JP-6

The countermeasure for LFO leakage

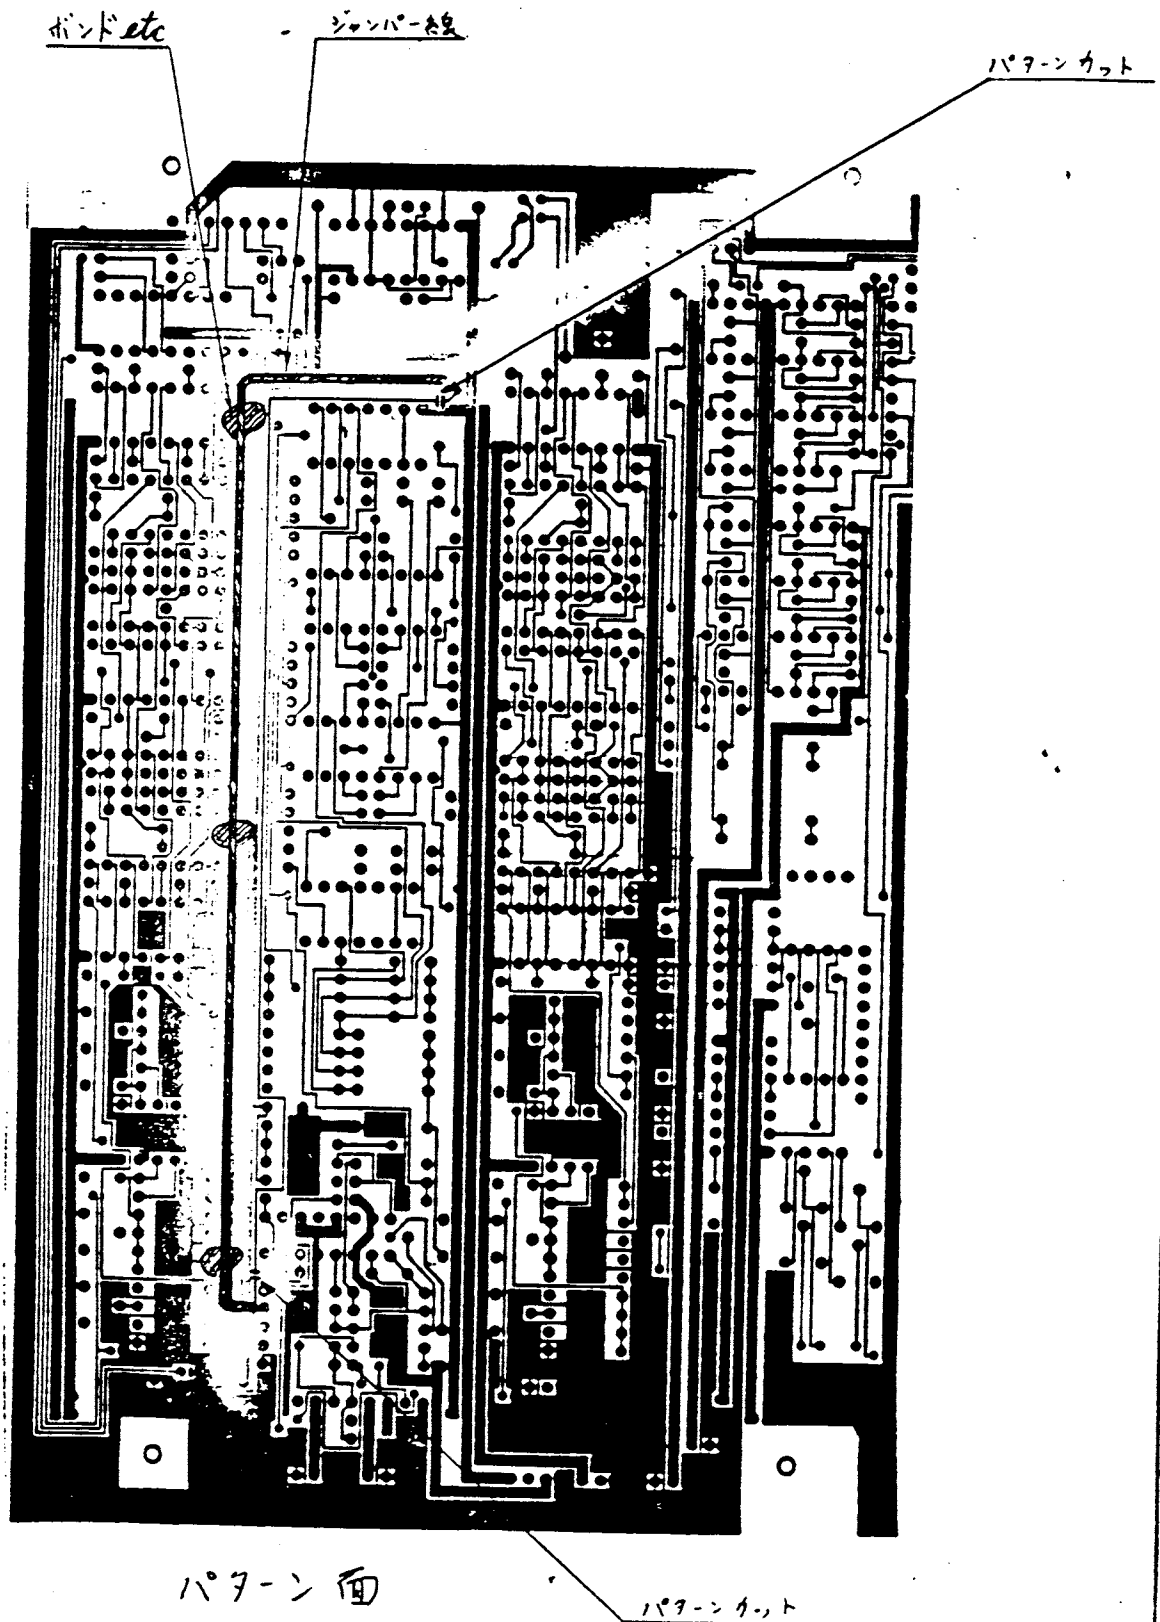
This LFO leakage is caused among wires which are wired between CPU board and MODULE (2 VOICES)/ MODULE (4 VOICES) boards.

Please separate a bundle of the wires into two bundles to eliminate the LFO leakage. Please refer to the attached drawing.

NOTE : The above modification has already been taken to JP-6 from the serial number 280950. Accordingly, this modification is effective on JP-6 with serial numbers from 250100 to 280949.
